UNITED STATES  
DEPARTMENT OF THE INTERIOR  
BUREAU OF LAND MANAGEMENT

Revised BOP language  
- Revised BOP & closed loop schematic  
- Co-flex hose documentation  
- Revised location schematic/dimensions

COTTON DRAW 10 FED 2H – DRILLING SUNDRY  
MHC 10.04.11

**Cotton Draw 10 Fed Com 2H**  
**Devon Energy Production Company, LP**  
**30-015-39230-00-X1**  
**Oct 13, 2011**  
**Conditions of Approval**

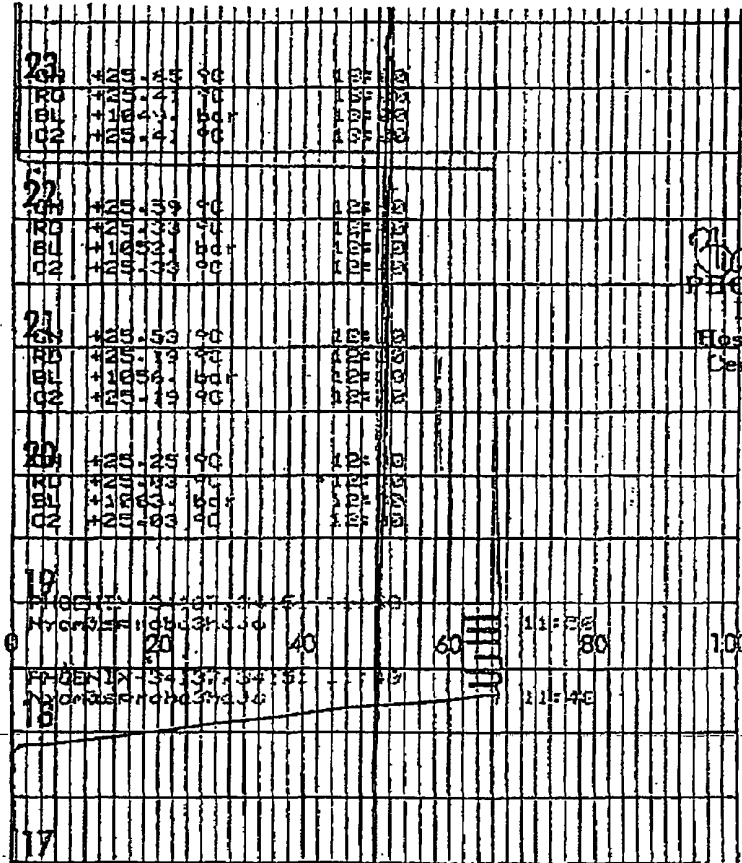
Devon requests a variance to use a flexible line with flanged ends between the BOP and the choke manifold (choke line). The line will be kept as straight as possible with minimal turns.

**Manufacturer: ContiTech Beattie Corp, Houston, TX**

**Serial Number: 34137**

**Length: 11.43 m Size: 3" Ends – 4-1/16" flanged**

**WP rating: 10,000 psi WP Anchors required by manufacturer – No**

1. Addition of a 3<sup>rd</sup> ram meeting 3M specifications of original APD is ok.
2. Addition of a 3<sup>rd</sup> ram meeting 3M specifications of original APD is ok.
3. Utilization of 3M BOPE is ok. BOP Requirement for well is 3M in original APD.
4. **Variance approved to use flex line with Serial #34137 from BOP to choke manifold. Check condition of 3" flexible line from BOP to choke manifold, replace if exterior is damaged or if line fails test. Line to be as straight as possible with no hard bends and is to be anchored according to Manufacturer's requirements. Anchor requirements to be onsite for review.**

# 13-5/8" 3M BOPE & Closed Loop Equipment Schematic

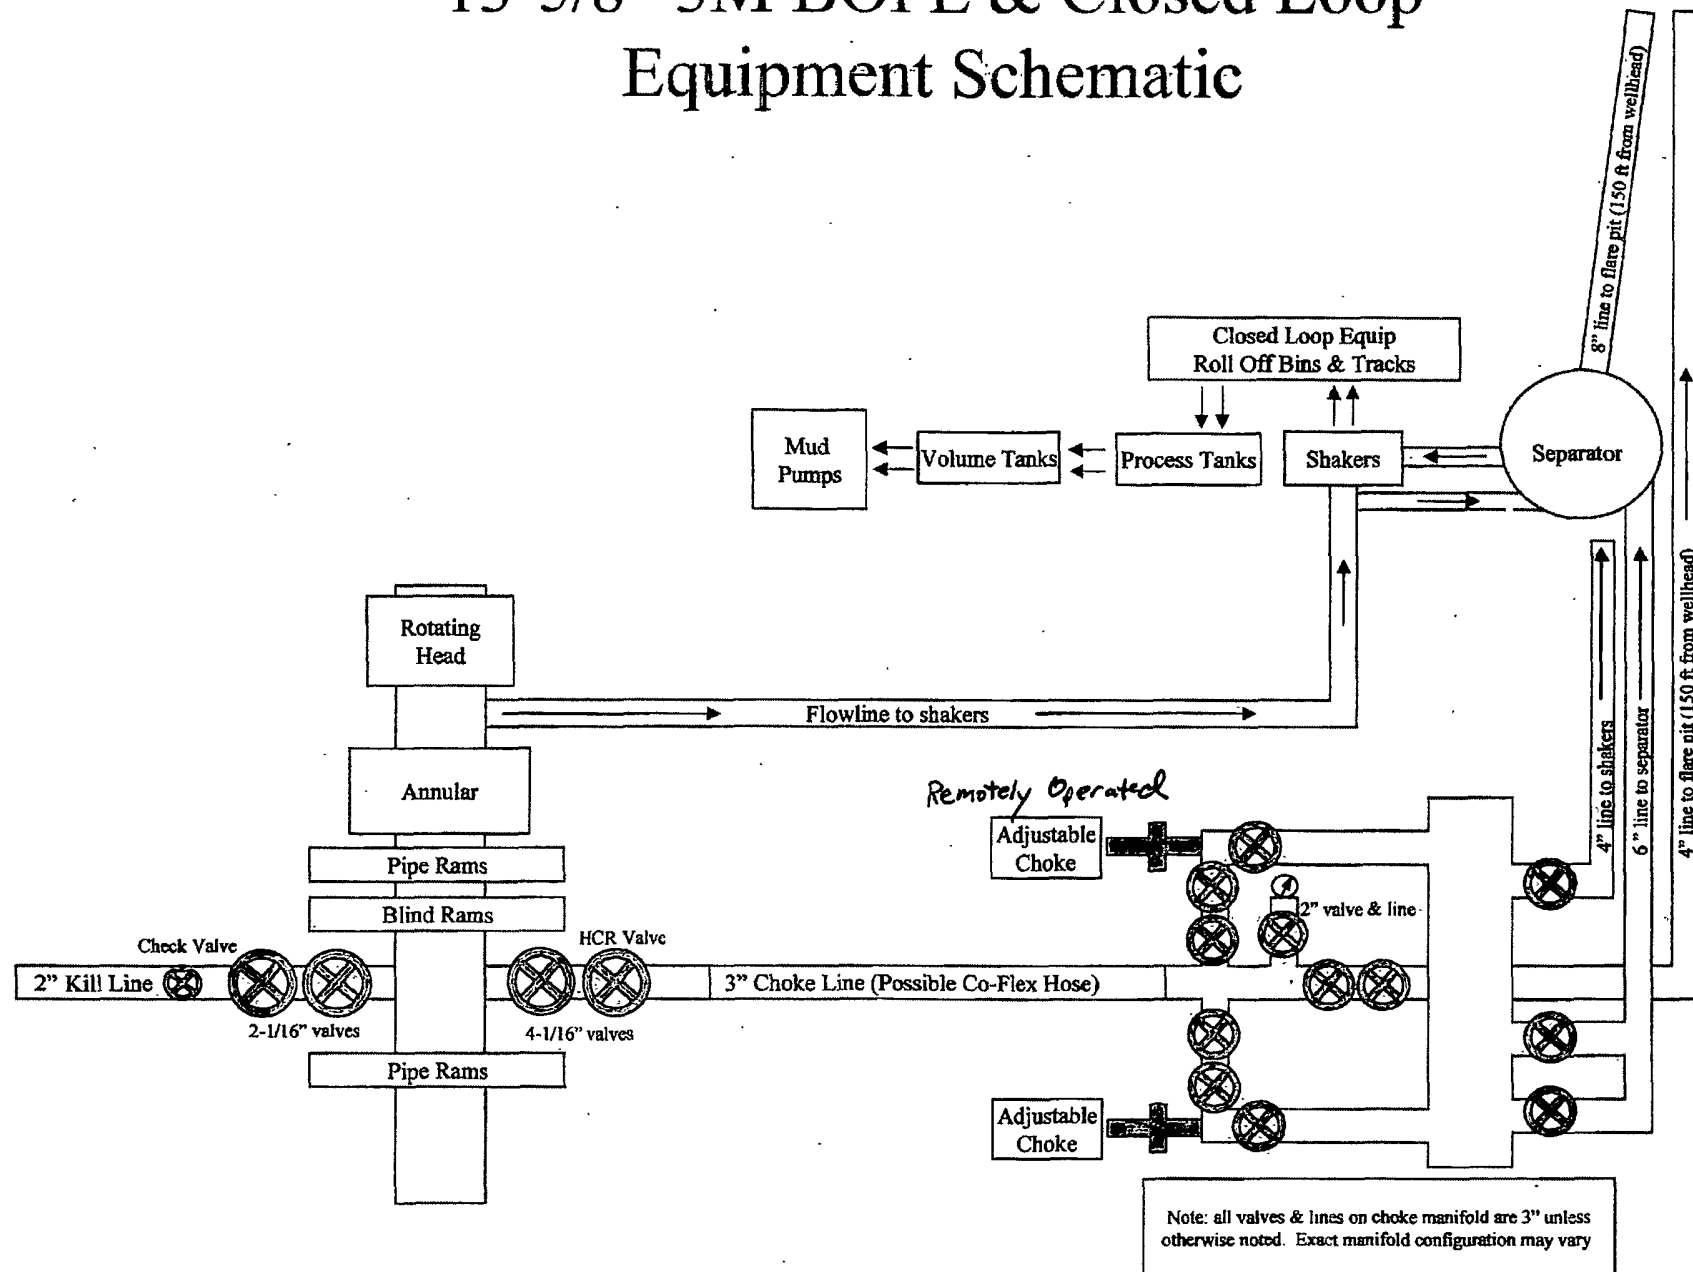
The BOP system used to drill the intermediate hole will consist of a 13-5/8" 3M Triple Ram and Annular preventer. The BOP system will be tested as per BLM Onshore Oil and Gas Order No. 2 as a **3M system** prior to drilling out the surface casing shoe.

The BOP system used to drill the production hole will consist of a 13-5/8" 3M Triple Ram and Annular preventer. The BOP system will be tested as per BLM Onshore Oil and Gas Order No. 2 as a **3M system** prior to drilling out the intermediate casing shoe.

The pipe rams will be operated and checked as per Onshore Order No 2. A 2" kill line and 3" choke line will be incorporated into the drilling spool below the ram BOP. In addition to the rams and annular preventer, additional BOP accessories include a kelly cock, floor safety valve, choke lines, and choke manifold rated at **3,000 psi WP**.

1. 12-1/4" hole (645' – 4275') for 9-5/8" Intermediate Casing: 13-5/8" 3M double ram and annular revised to be 3M triple ram and annular
2. 8-3/4" hole (4275' – 12603') for 5-1/2" Production Casing: 13-5/8" 3M double ram and annular revised to be 3M triple ram and annular
3. BOP related equipment revised to be 3M instead of 5M .
4. **Devon Energy Production requests a variance for the H&P Flex Rig to use a co-flex line between the BOP and choke manifold.**

# H&P Flex Rig Location Layout

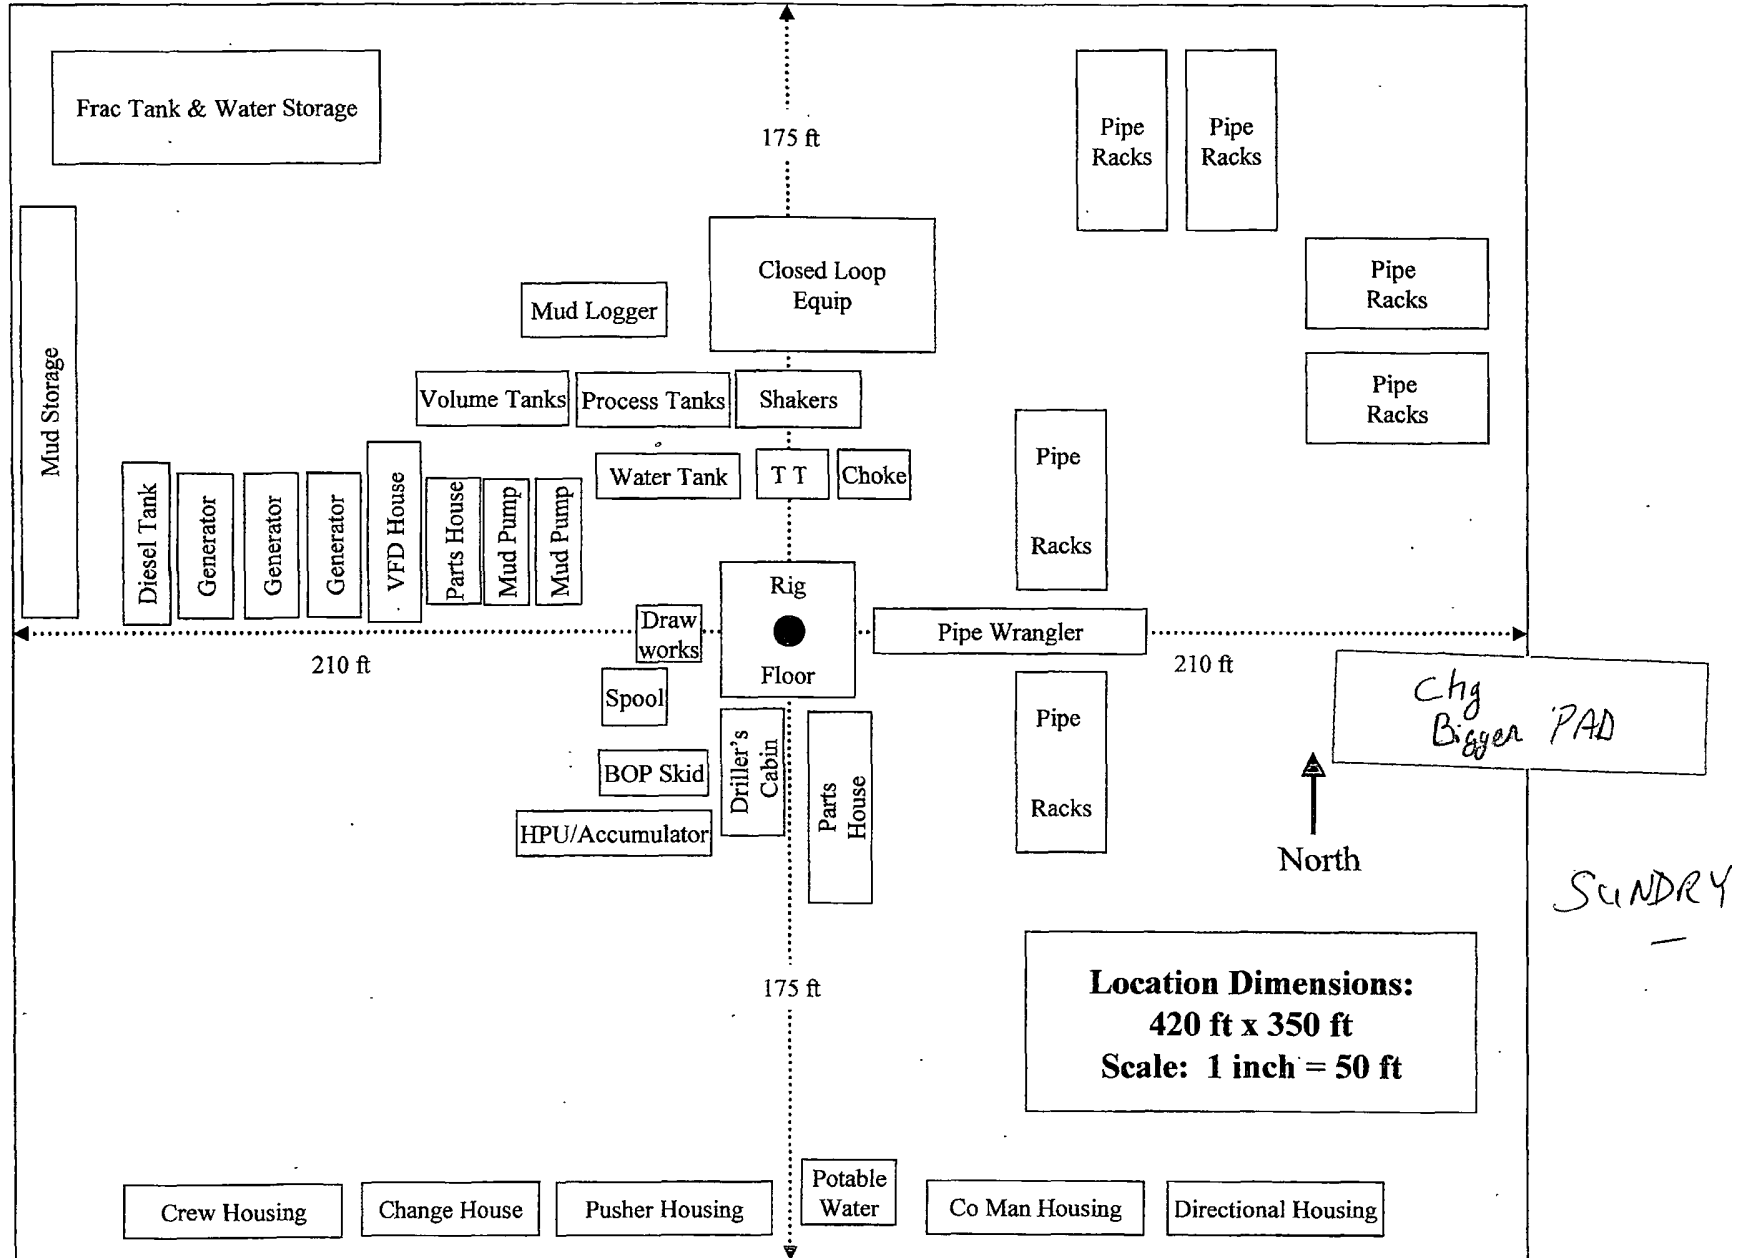
5. To use a revised location dimension required for an H&P Flex Rig, instead of the original pad associated with Rig McVay 6. Original approved location dimension is 420' x 350' with access road on the east of the south side. Location dimension required by H&P Flex Rig is stated to be 420' x 350' with access road not indicated and north not indicated.
